RFI

RFI #: 63  
 Date: 2/22/2012  
 Job: EB-02 Keller Springs Lofts  
 Phone: 877-777-5115

RFI #: 134  
 Date: 5/30/2012  
 Job: EB-02 Keller Springs Lofts  
 Phone: 877-777-5115

RFI #: 128  
 Date: 5/29/2012  
 Job: EB-02 Keller Springs Lofts  
 Phone: 877-777-5115

Subject: First Floor Grills Near Elevator #2  
 Drawing: A3.1D, M3.1, Detail 7/M4.2  
 Cost Impact: None  
 Spec Section:  
 Schedule Impact: None

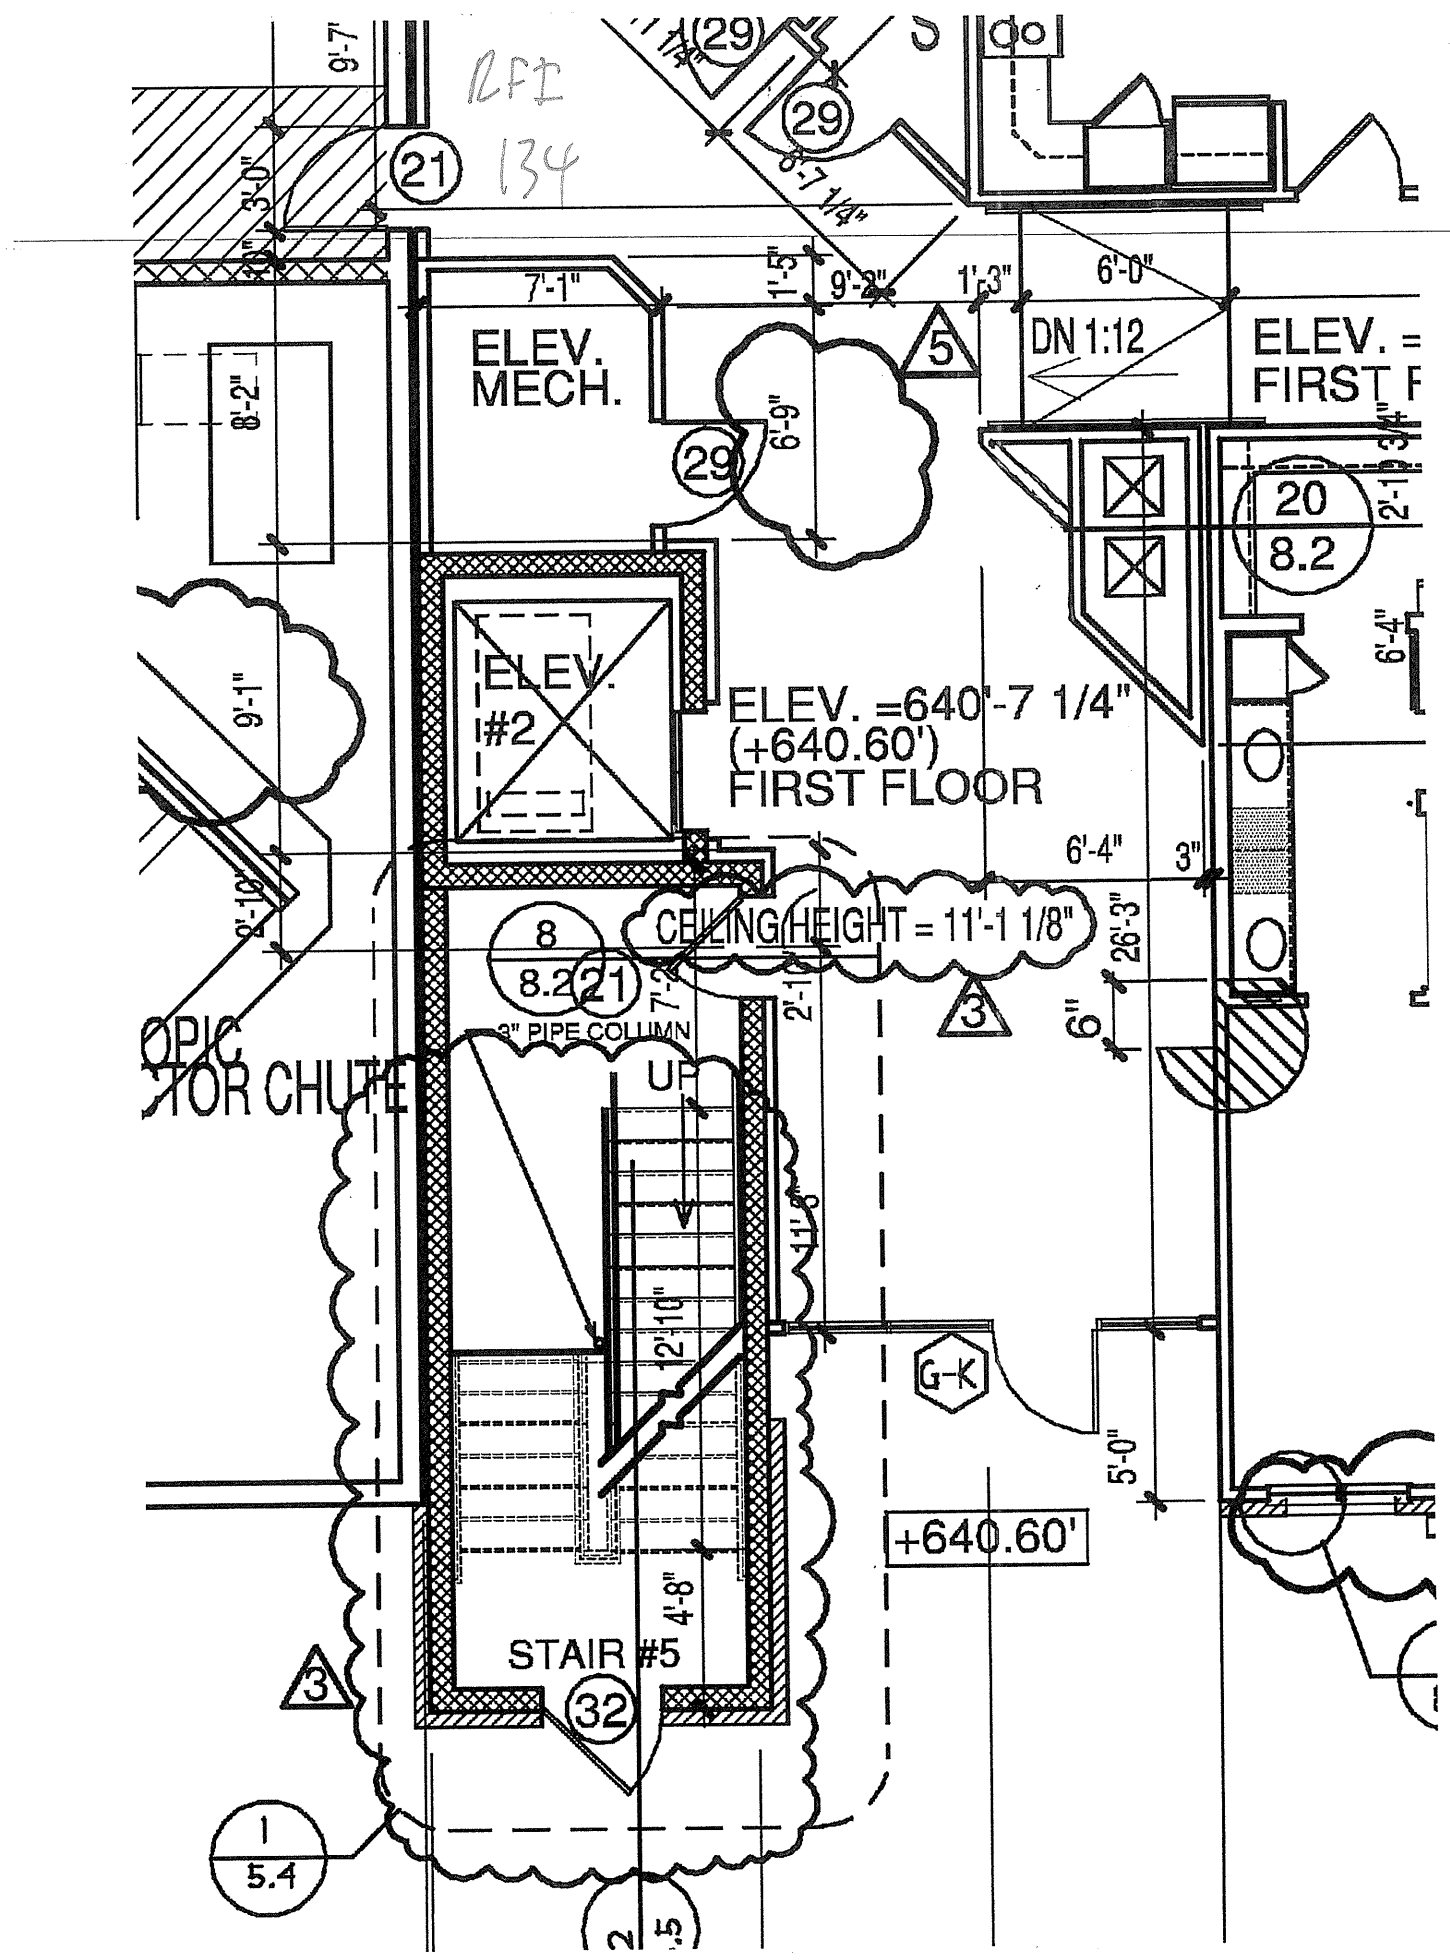
**Request:**  
 Due to the ramp at the mechanical shaft (near elevator #2), there is an added wall on the first floor that is not shown on the other floors. This additional wall will cause issues with the grill located in that area. Detail 7/M4.2 shows the walls as they will be on floors 2, 3 and 4. Can the additional wall be modified to give the HVAC sub room for his grill? Please see attached sketch.

**Response:** This sketch looks to be what was proposed on RFI-128. GC to verify they are the same solution. I take no exception to this solution.

Subject: Corridor duct issues  
 Drawing:  
 Cost Impact: None  
 Spec Section:  
 Schedule Impact: None

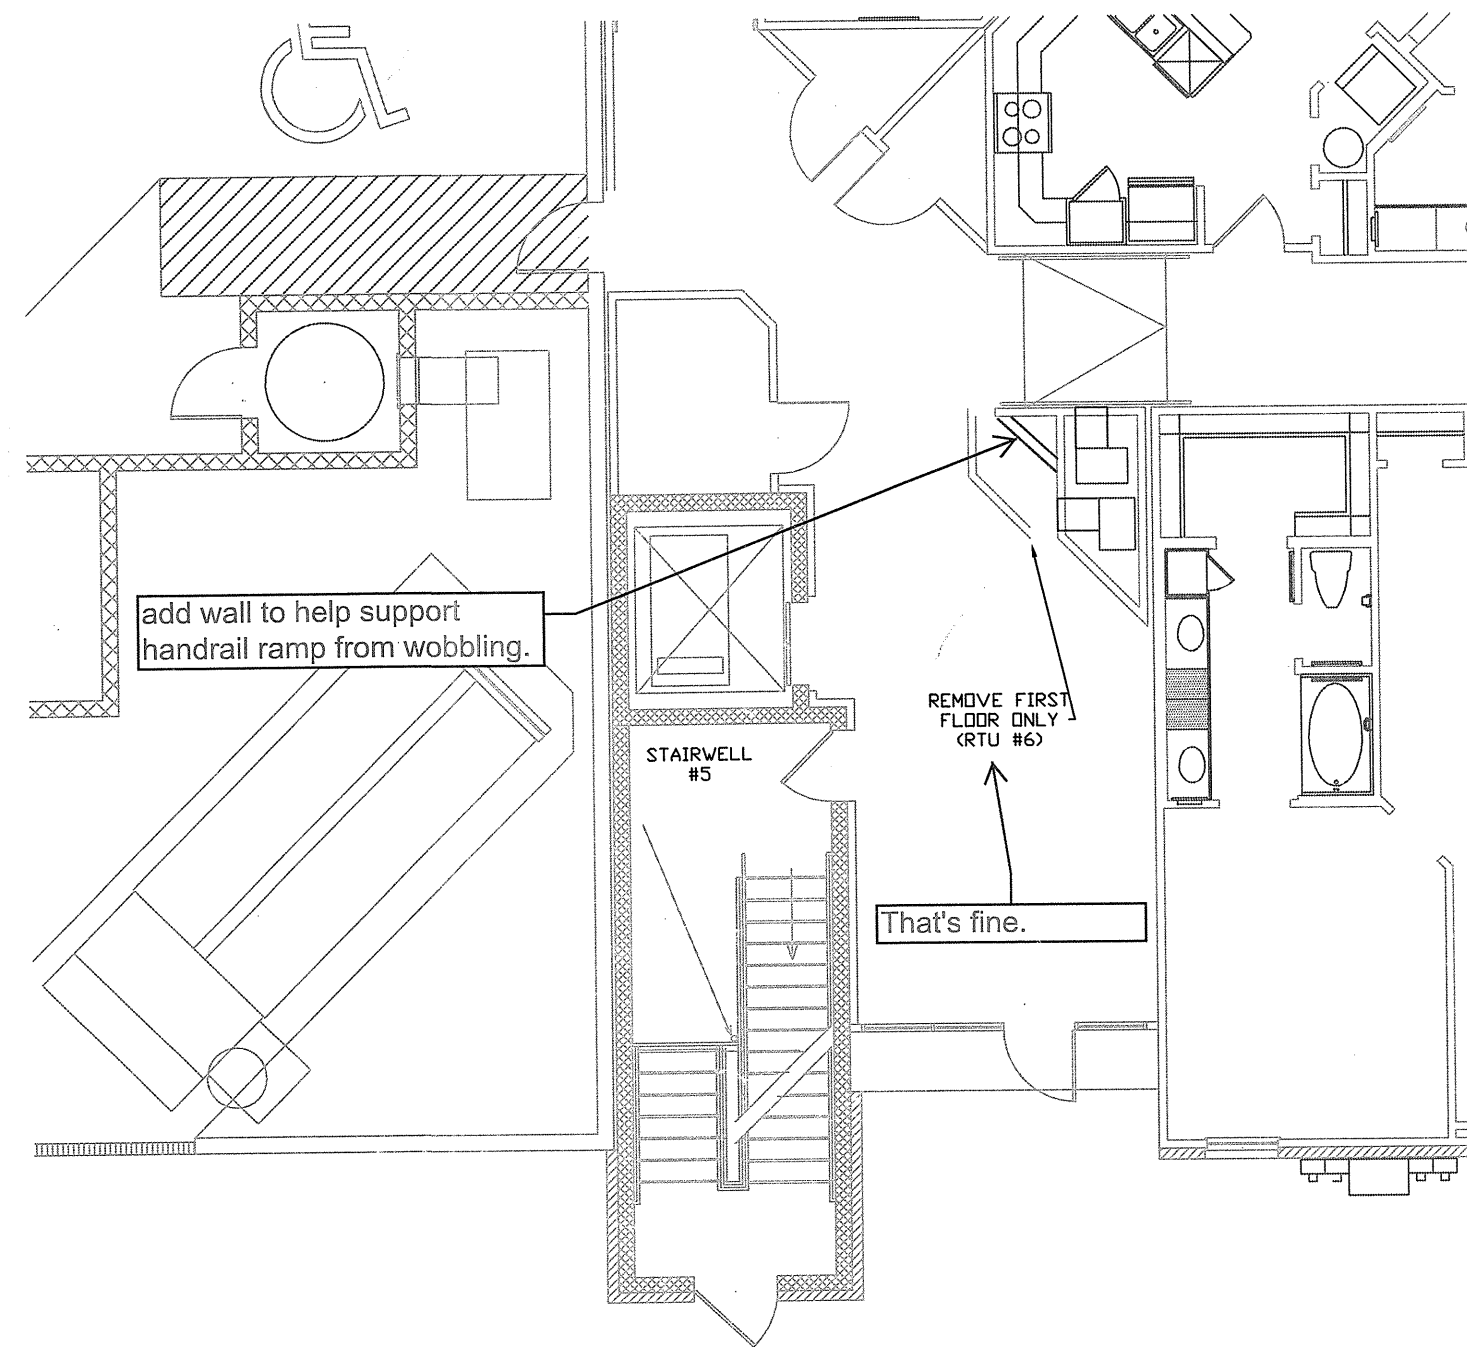
**Request:**  
 We are laying out the corridor duct that run through the shafts from the roof and have found some conditions that need addressing. The attached drawings and the following narrative should clarify these items:  
 1. The curved corridor wall at section C needs to be flat or have flat areas to mount the grilles.  
 2. The corridor wall at the shaft works well on floors 2-4 but changes on the first floor and creates a problem. Suggest using the upper floor configuration on the first floor.

**Response:**  
 1- For air grills being installed in curved walls, I recommend popping the grill 2-3 inches off of the wall to allow for gypsum board to wrap around the grill where it protrudes from the wall.  
 2- The upper floors will not work due to the ramp and handrail. See next pages for possible solution.
